ILLINOIS POWER COMPANY

Subject: Clinton Power Station Unit 1
Request for Additional Information Concerning the
Safety Parameter Display System for Clinton Power Station

Response to Request for Additional Information Concerning
the Clinton 1 Safety Parameter Display System

Diagram of Online Monitoring of Isolators

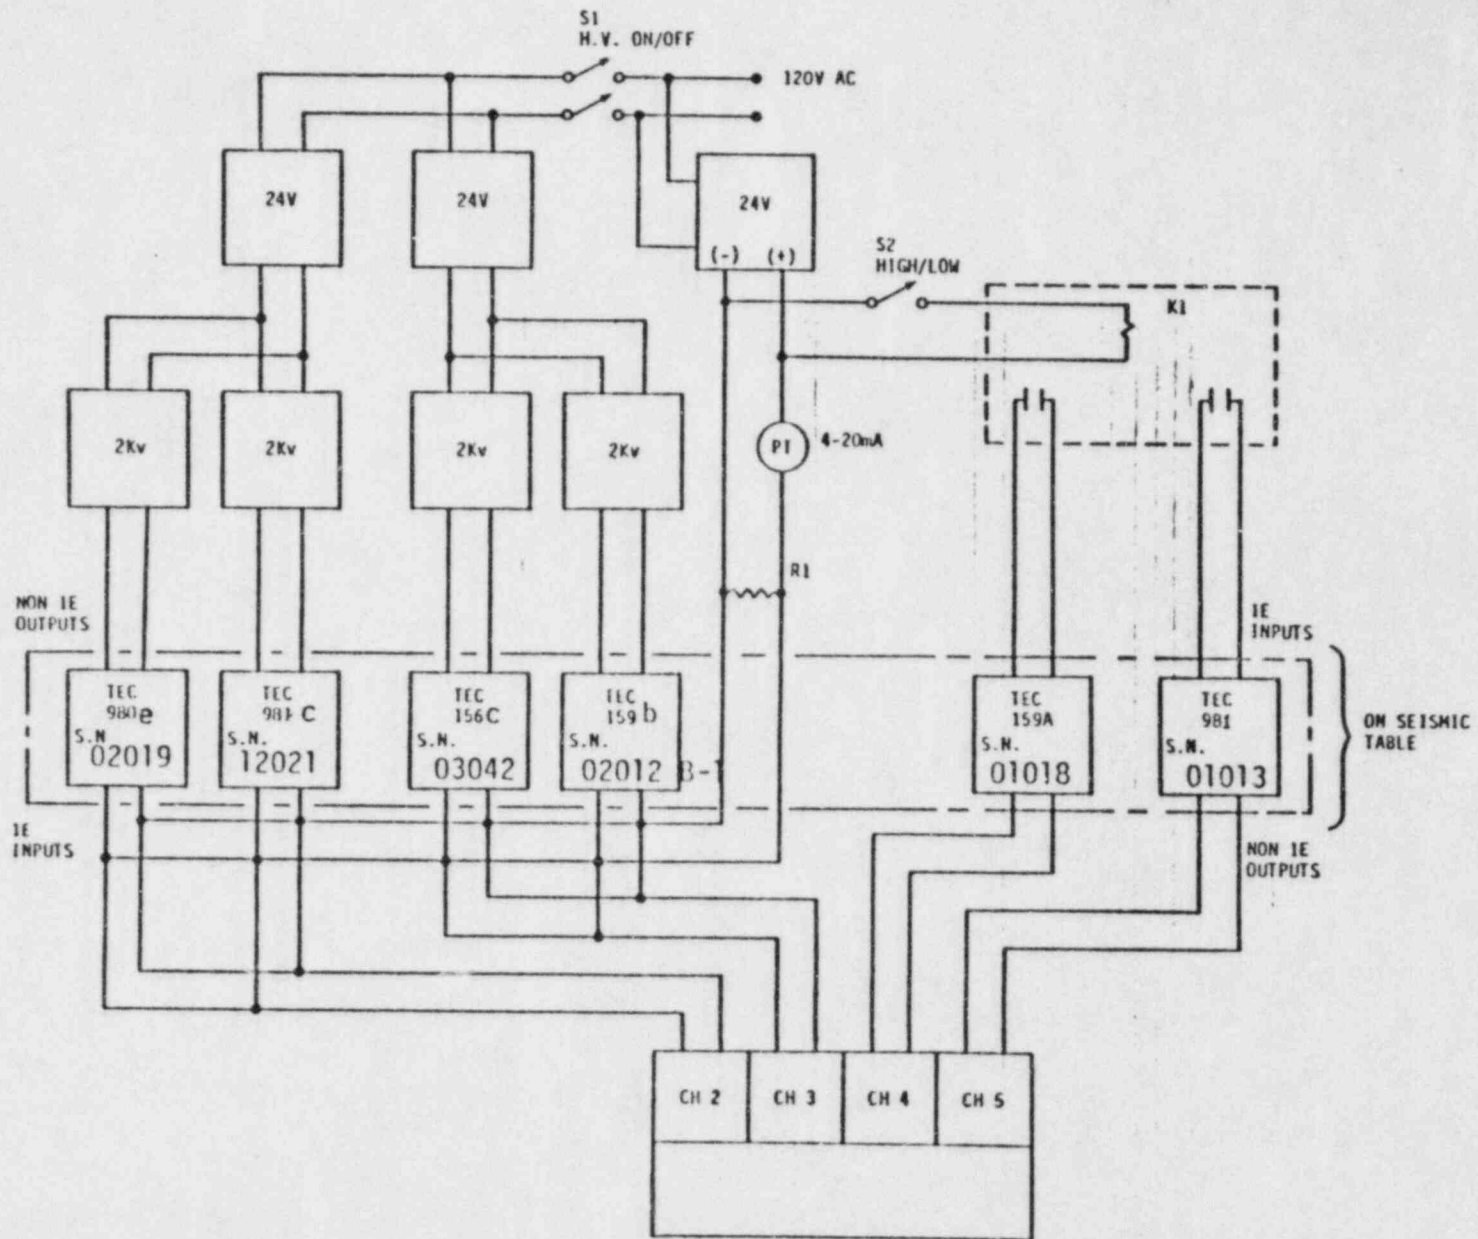
For each type of device used to accomplish electrical isolation, describe the specific testing performed to demonstrate that the device is acceptable for its application(s). This description should include elementary diagrams when necessary to indicate the test configuration and how the maximum credible faults were applied to the devices.

Data to verify that the maximum credible fault was applied to the output of the device in the transverse mode (between signal and return) and other faults were considered (i.e., open and short circuits).

A Honeywell absolute pressure transmitter was placed in operation as the analog input to analog isolators, and the IE inputs were recorded by a strip chart recorder. During the seismic event, 2000 Vdc was applied continuously to the outputs of the isolators; no transients were recorded on the IE input line, nor was there any damage to the input or recording electronics. See Attachment 1 for a diagram of the test setup.

SPDS 5S DISPLAY

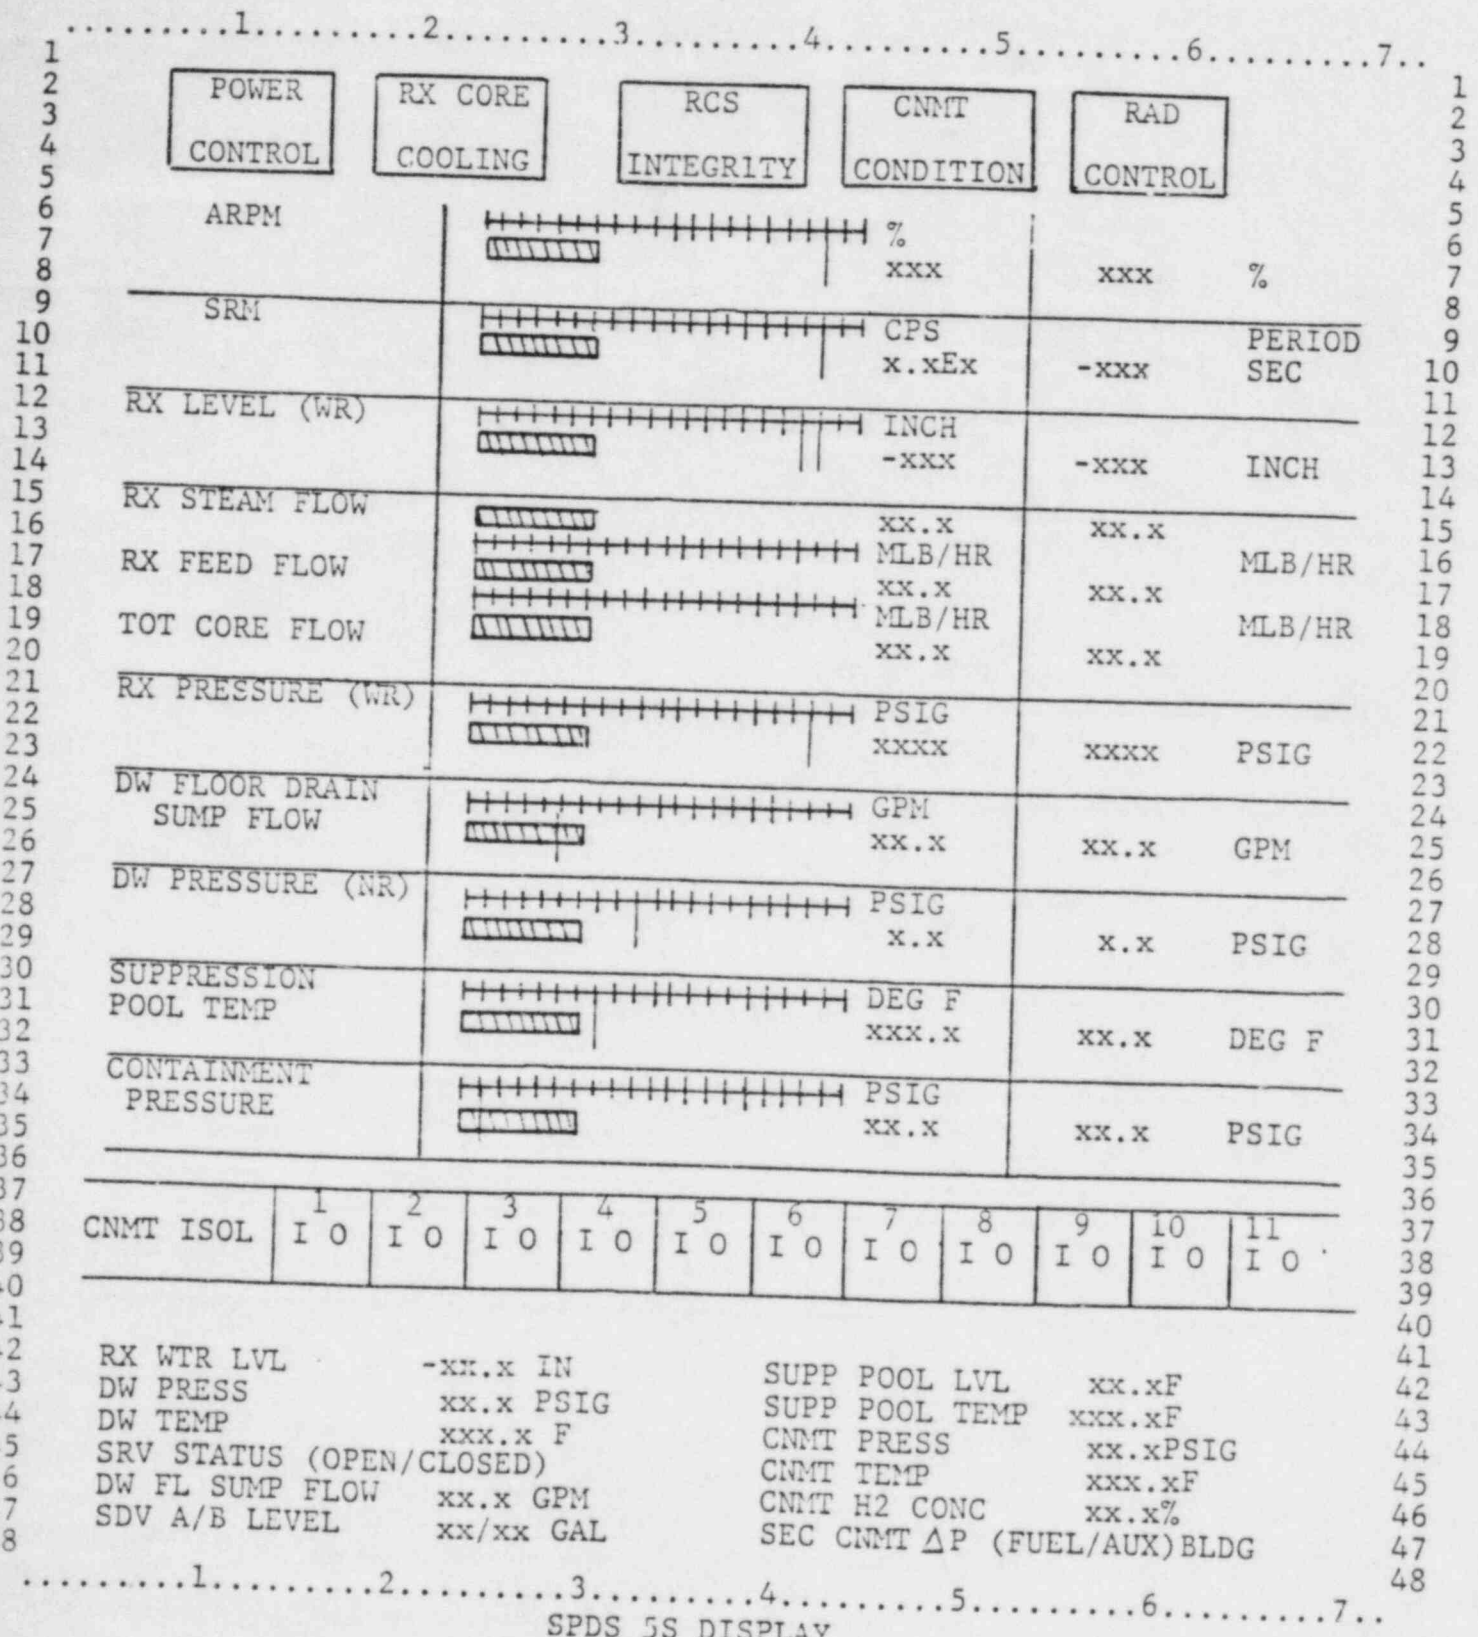
1. Provide an explanation why the inconsistent use of color code meanings will not mislead the operator; that is, since yellow denotes "normal" on the primary SPDS display but denotes "abnormal" or "trending high" on the ARM/PRM, there seems to be a risk of the operator misinterpreting a yellow data point as being "normal" on the ARM/PRM portion of the SPDS when it is actually trending high.
2. Provide discussion/analysis explaining why control of the ARM/PRM displays from the primary SPDS area is unnecessary. The discussion should address the situation in which the ARM/PRM has been switched to a lower level display rather than the "status grid display" and has been left in that condition.
3. Provide a diagram of the control room showing the primary SPDS display location, the ARM/PRM location, the distance between the two locations, and the viewing angle.

IPC has added a "Rad Control" (Critical Safety Function - CSF) alarm to the primary SPDS display which is fed from the ARM/PRM system's High Radiation Summary Alarm (see the Attachment #2 format for the revised Primary SPDS display). With the inclusion of this alarm, the primary SPDS display is now a stand-alone high level indication of plant CSFs. Therefore, the primary SPDS will provide a complete and unambiguous indication to the plant operator(s). The potential for confusion between the color uses on Nuclenet and the ARM/PRM systems is removed.
